EL'S NAME Stk. S.S. "YEBOSHI MARU" Report Nov. No. 3993

remarks of the Chief Ship Surveyor are desired on this case for the consideration of the Classing Committee.

of Survey 2nd S.S. No. 3.2

THICKNESSES OF PLATING ascertained by drilling, and comparison of same with the original thicknesses.

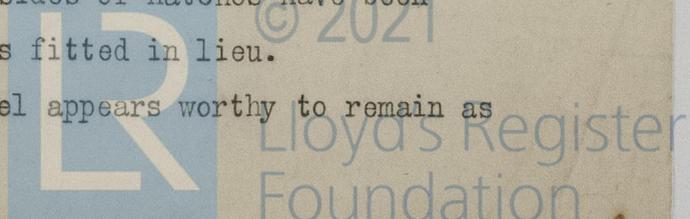
The Kobe Surveyors report this vessel has been placed in dry dock, and the requirements of the 2nd.s.s.No.2 due 7,23^{partly} carried out.

The shell plating has been drilled at the request of the Government Surveyor with results as shewn above, which may be considered satisfactory.

The bottom has been cleaned and coated and minor repairs effected.

The portable pillars at sides of hatches have been removed and girders and corner pillars fitted in lieu.

It is submitted the vessel appears worthy to remain as

classed with record of survey 6,23 Kob., the notation of s.s.No.2 to be deferred until the survey is complete.

To complete the survey all tanks to be examined internally and bunkers examined.

The Surveyors should ~~also~~ be requested to state whether, when the tanks and bunkers have been examined, all the requirements of a 2nd.s.s.No.3 will have been complied with, and if so, they should point out to the Owners that if desired by them notation of 2nd.s.s.No.3-6,23 could be assigned on the completion of the survey instead of the notation of s.s.No.2-23.
